Memorandum

To: Bassett Creek Watershed Management Commission (BCWMC)
From: Barr Engineering Co.
Subject: Item 5B. Consider Approval of Feasibility Study and Choose Concept to Implement for Medley Park Stormwater Treatment Facility Project, Golden Valley (CIP 2022 ML-12) - BCWMC June 17, 2021 Meeting Agenda
Date: June 10, 2021
Project: 23270051.51

5B Consider Approval of Feasibility Study and Choose Concept to Implement for Medley Park Stormwater Treatment Facility Project, Golden Valley (CIP 2022 ML-12)

Medley Park Stormwater Treatment Facility Feasibility Study

Figure 5.1

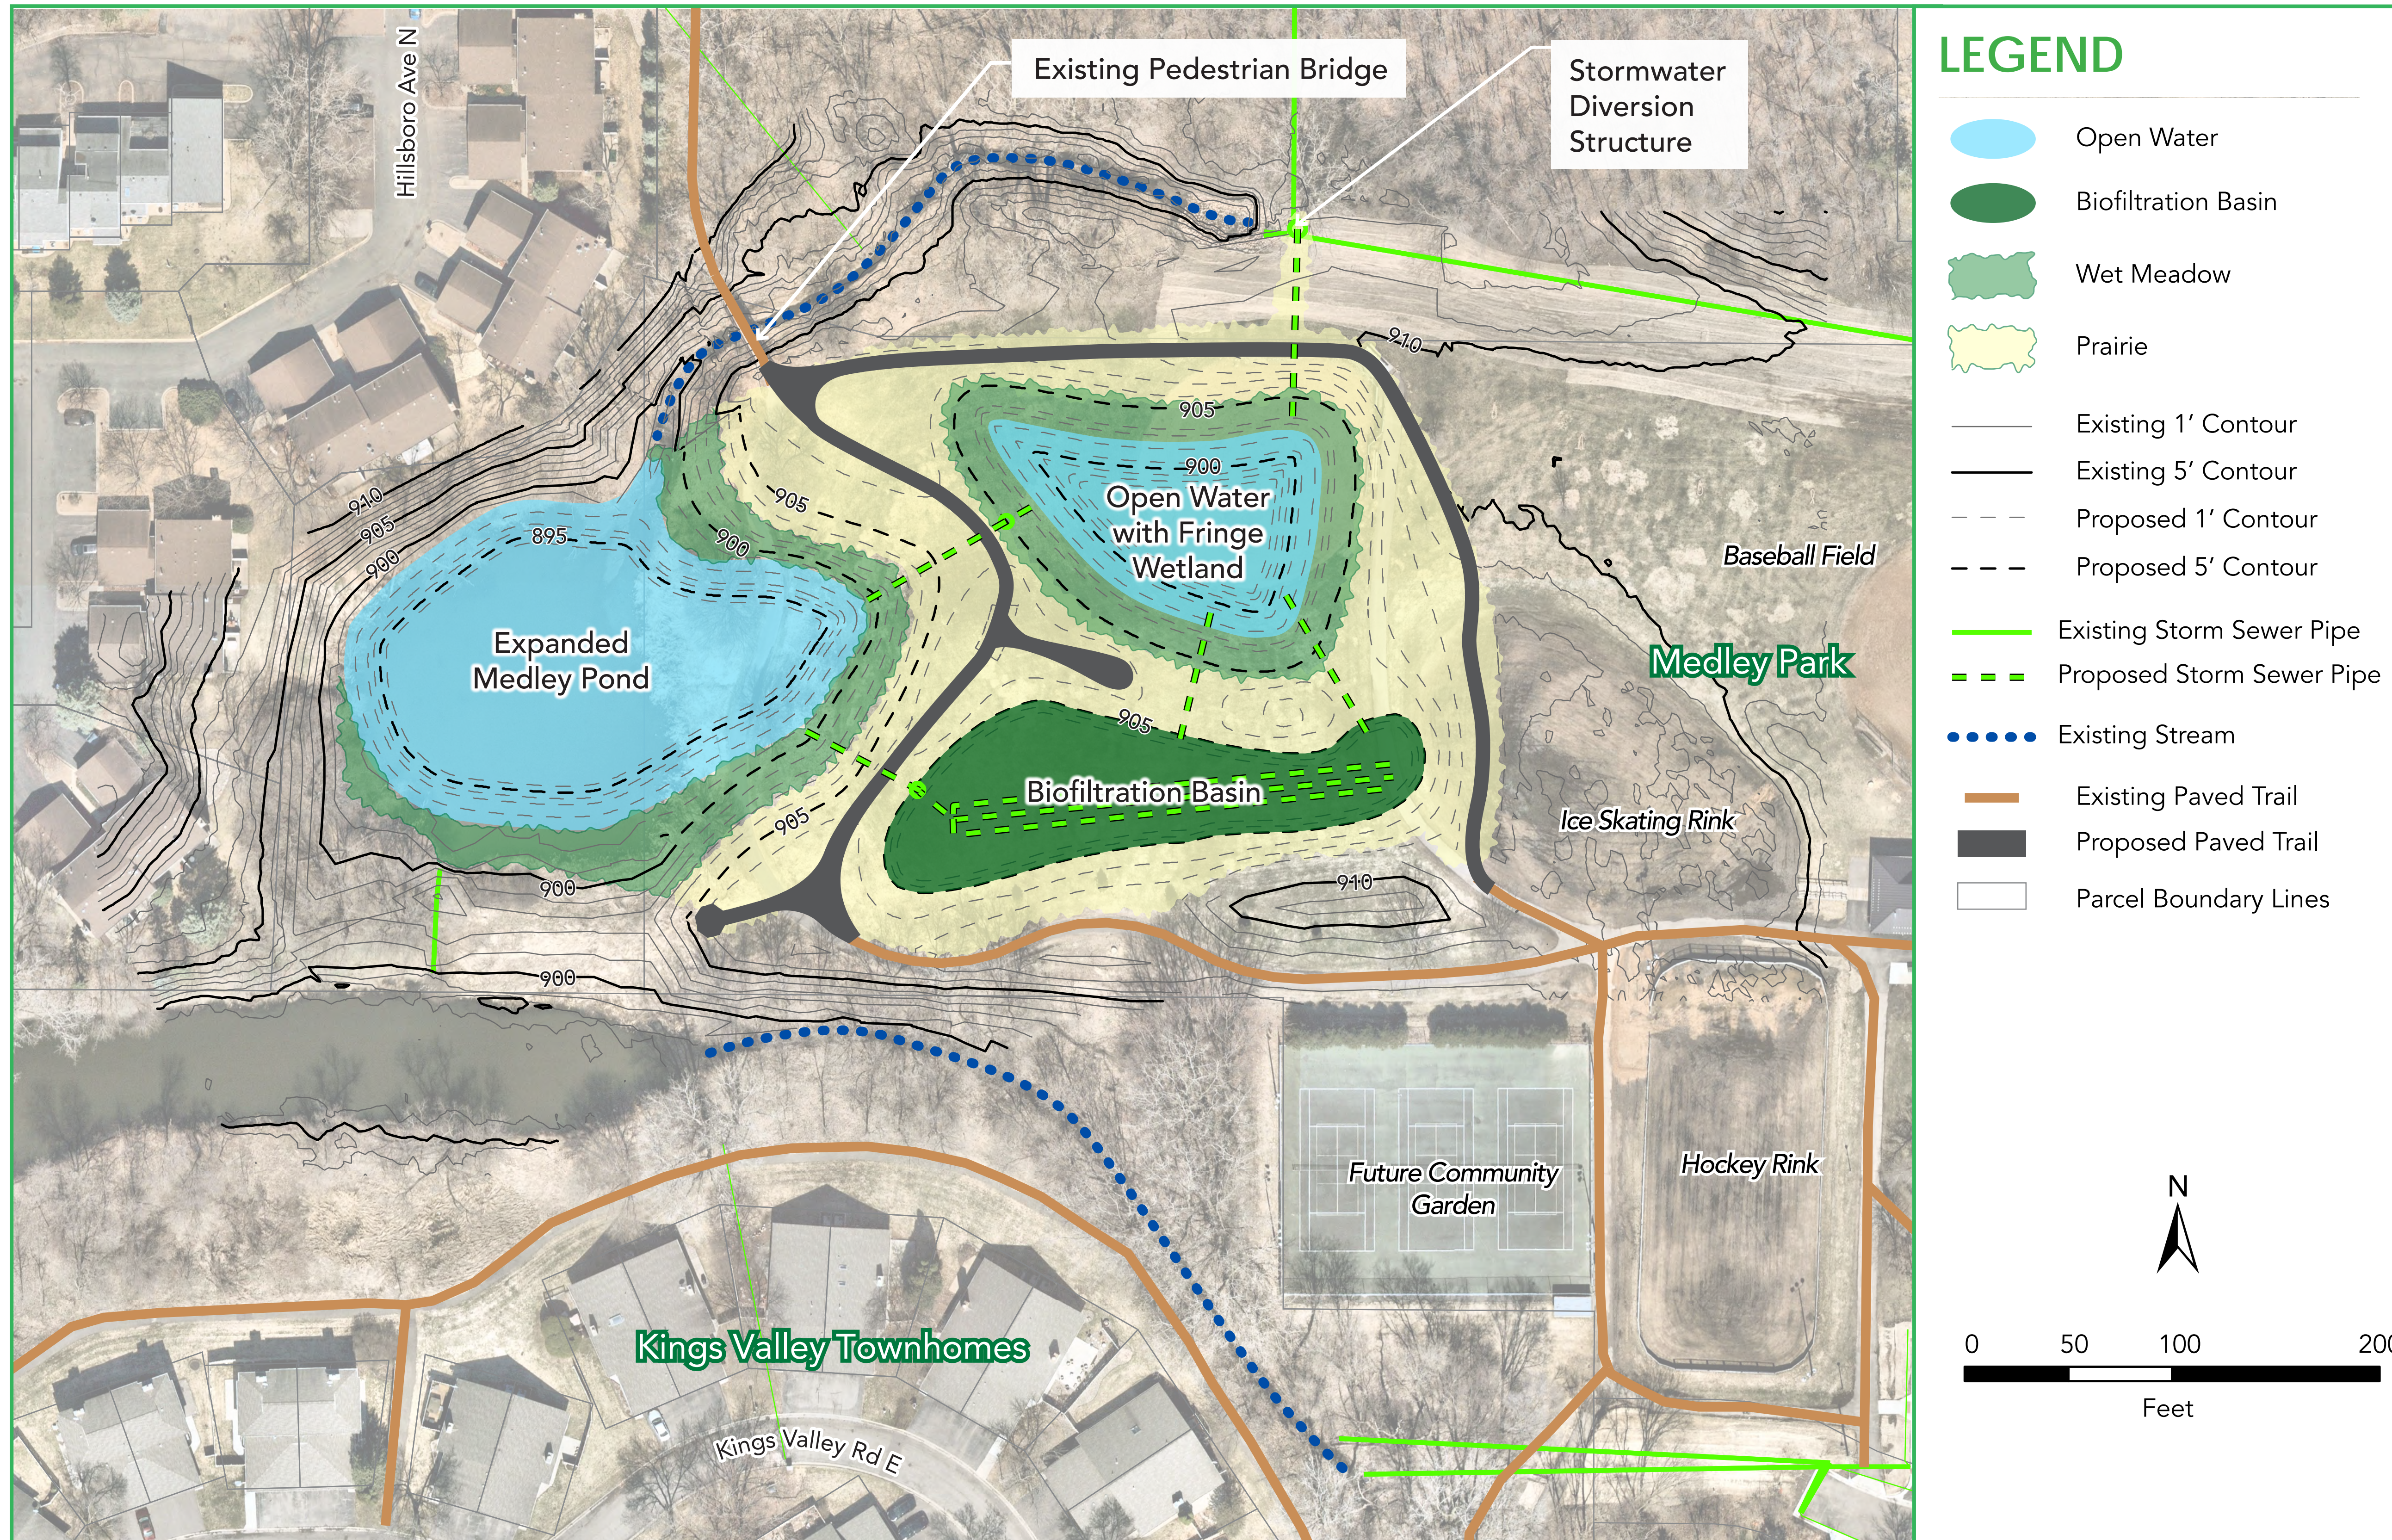
7. Section 5.1 – Concept 1; added text is underlined
 - a. Constructing a biofiltration basin downstream of the new stormwater pond. Two submerged and back-sloped storm sewer pipes would allow volume from the upstream new stormwater pond to enter the biofiltration basin while limiting the amount of floatable debris that can enter the basin. The storm sewer outlet to the biofiltration basin would be set one foot above the basin bottom to allow a minimum of one-foot treatment depth. A berm, with an emergency overflow, would be constructed to separate the pond and basin. The biofiltration basin would provide approximately 0.6 ac-ft of water quality treatment volume below the outlet rim elevation (2 feet above the basin bottom) and remove approximately 1.2 pounds of dissolved phosphorus per year through sorption to soils and sand. No filtration enhancements are proposed for the biofiltration basin substrate (i.e. iron-enhanced sand) to remove additional dissolved phosphorus. Limitations for the configuration of the basin and stormwater ponds, including existing stormwater infrastructure, existing topography, and the volume of stormwater runoff tributary to the park, results in a longer than recommended inundation period for iron-enhanced sand. Under longer periods of inundation, iron-enhanced sand removal efficiency decreases and can even release phosphorus under certain conditions.

Figure 5.2

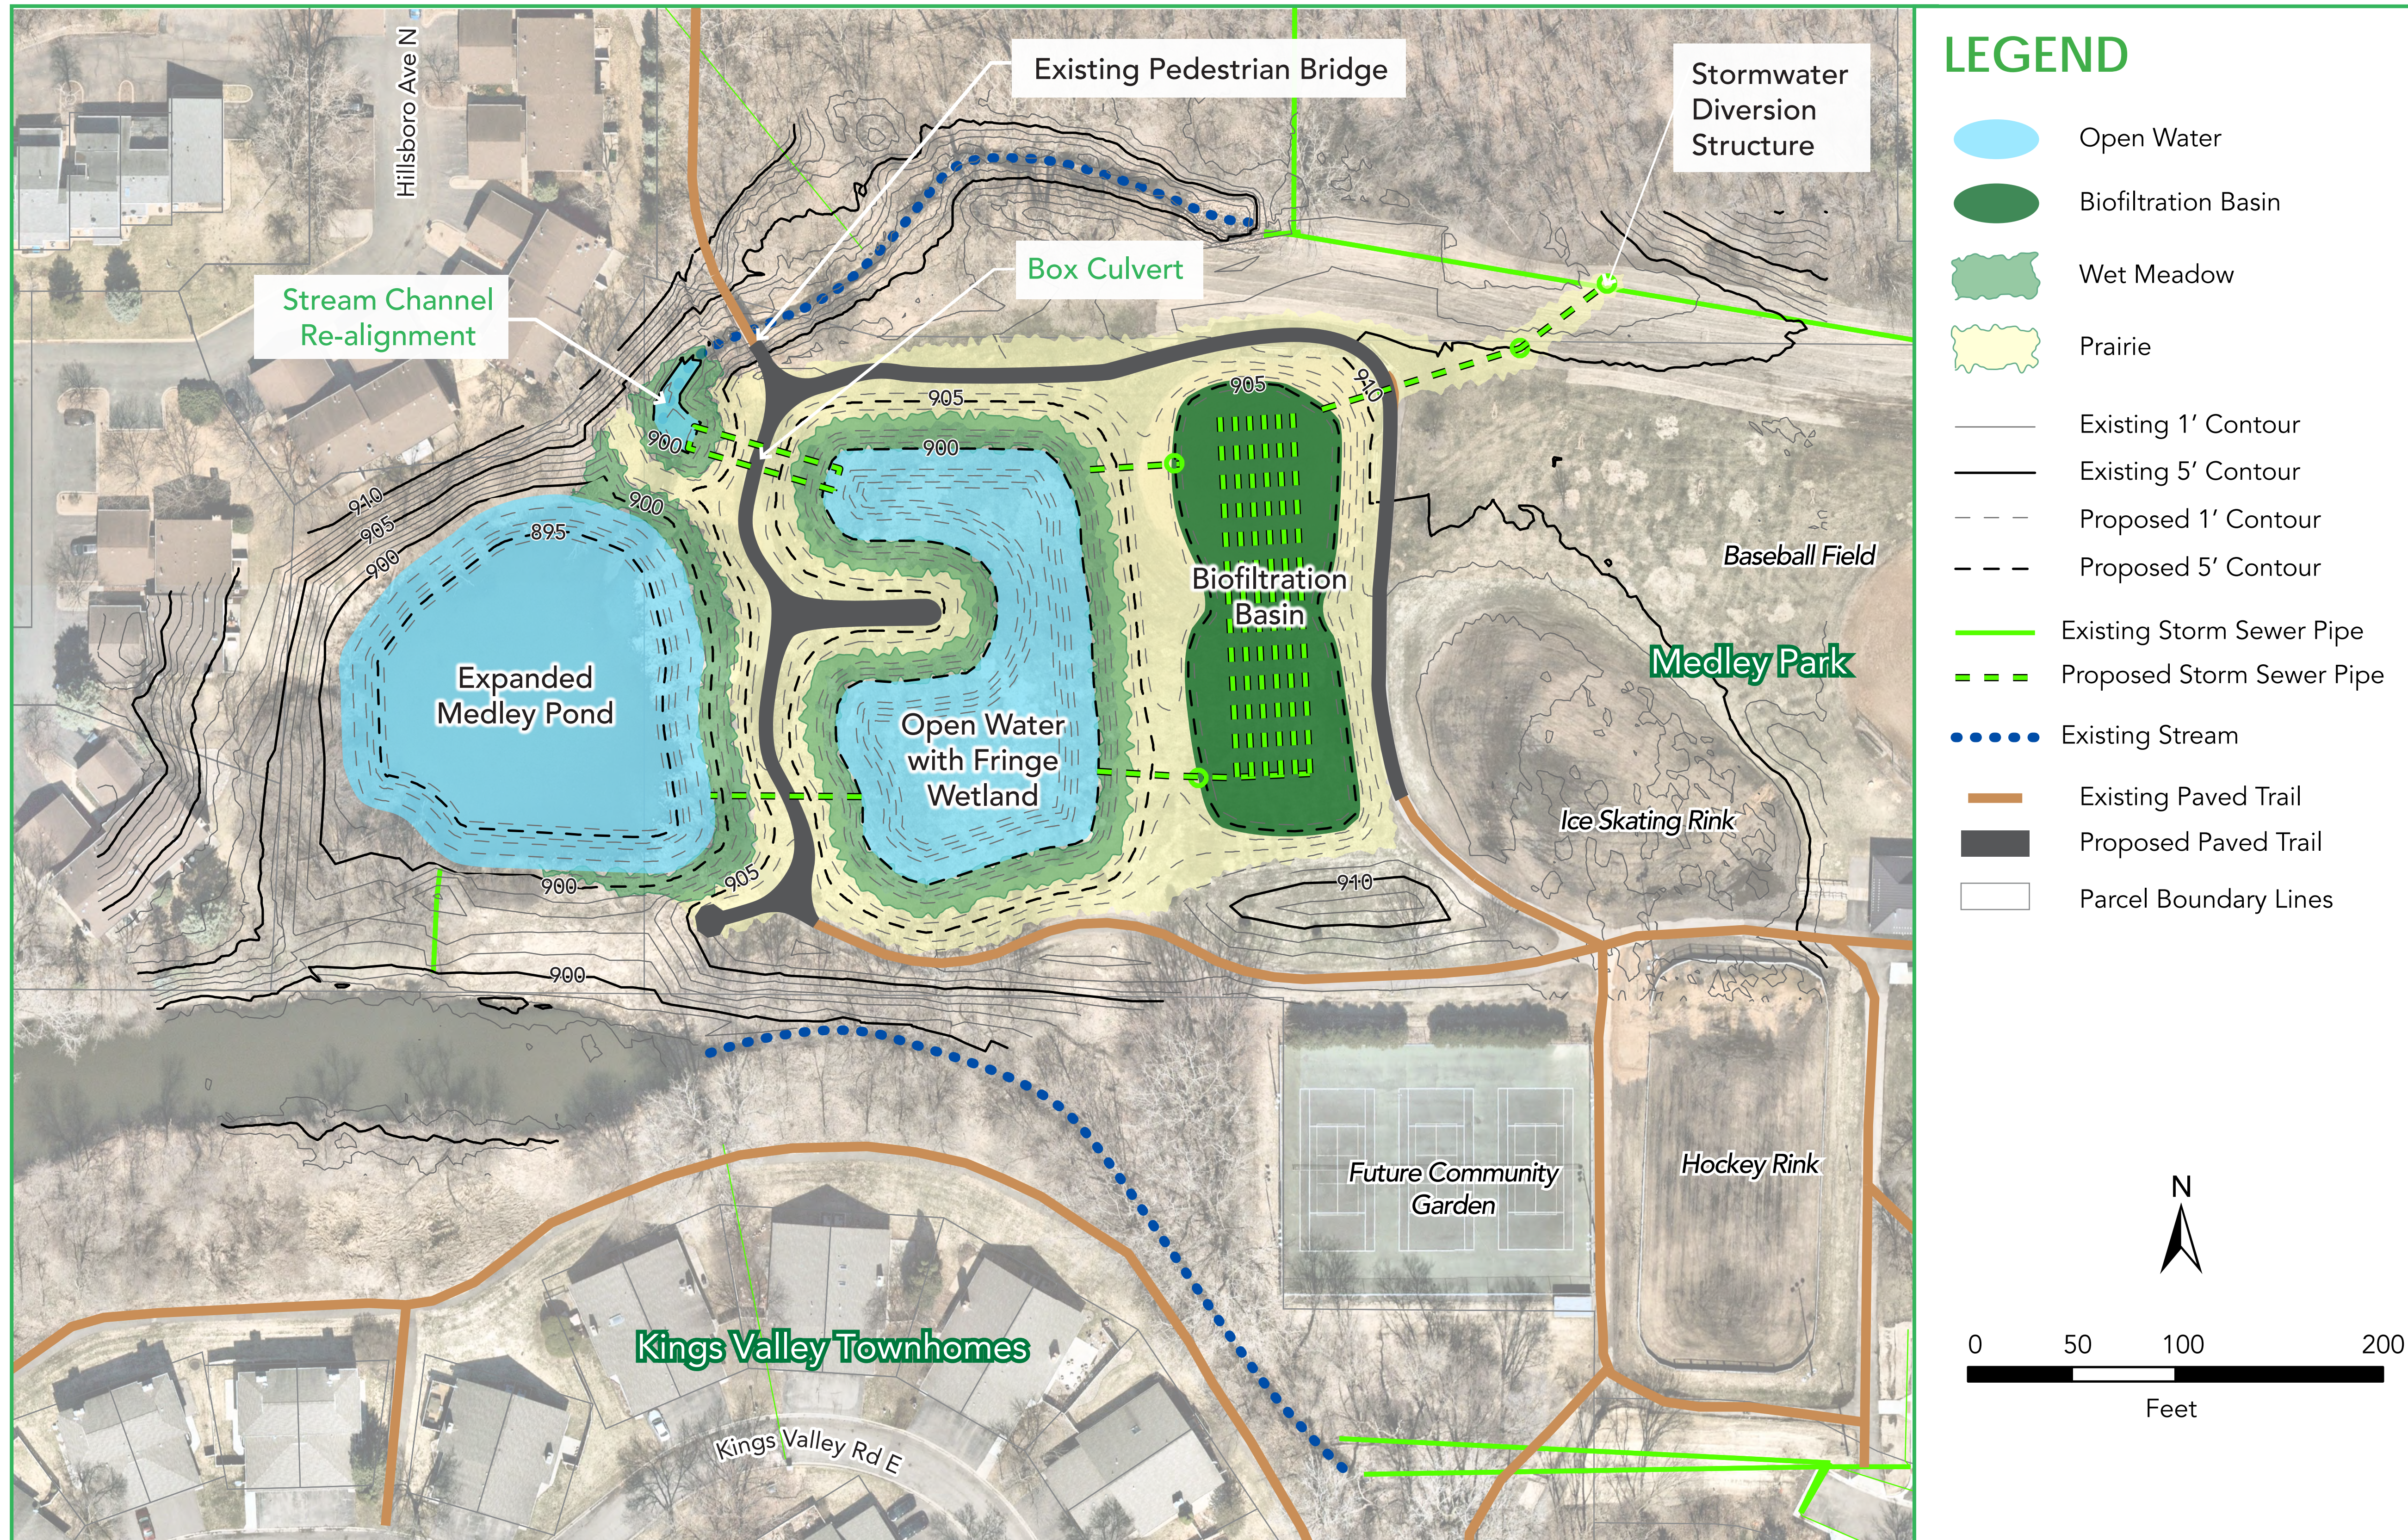
8. Section 5.2 – Concept 2; added text is underlined
 - a. Constructing a biofiltration basin in the eastern half of the construction area. The biofiltration basin would provide 0.7 ac-ft of water quality treatment volume below the outlet structures’ rim elevations (1.5 feet above the basin bottom). Flows from the basin would discharge west to the new stormwater pond. The biofiltration basin would remove approximately 6.3 pounds of dissolved phosphorus per year through sorption to soils and sand. No filtration enhancements are proposed for the biofiltration basin substrate (i.e. iron-enhanced sand) to remove additional dissolved phosphorus. Limitations for the configuration of the basin and stormwater ponds, including existing stormwater infrastructure, existing topography, and the volume of stormwater runoff tributary to the park, results in a longer than recommended inundation period for iron-enhanced sand. Under longer periods of inundation, iron-enhanced sand removal efficiency decreases and can even release phosphorus under certain conditions.
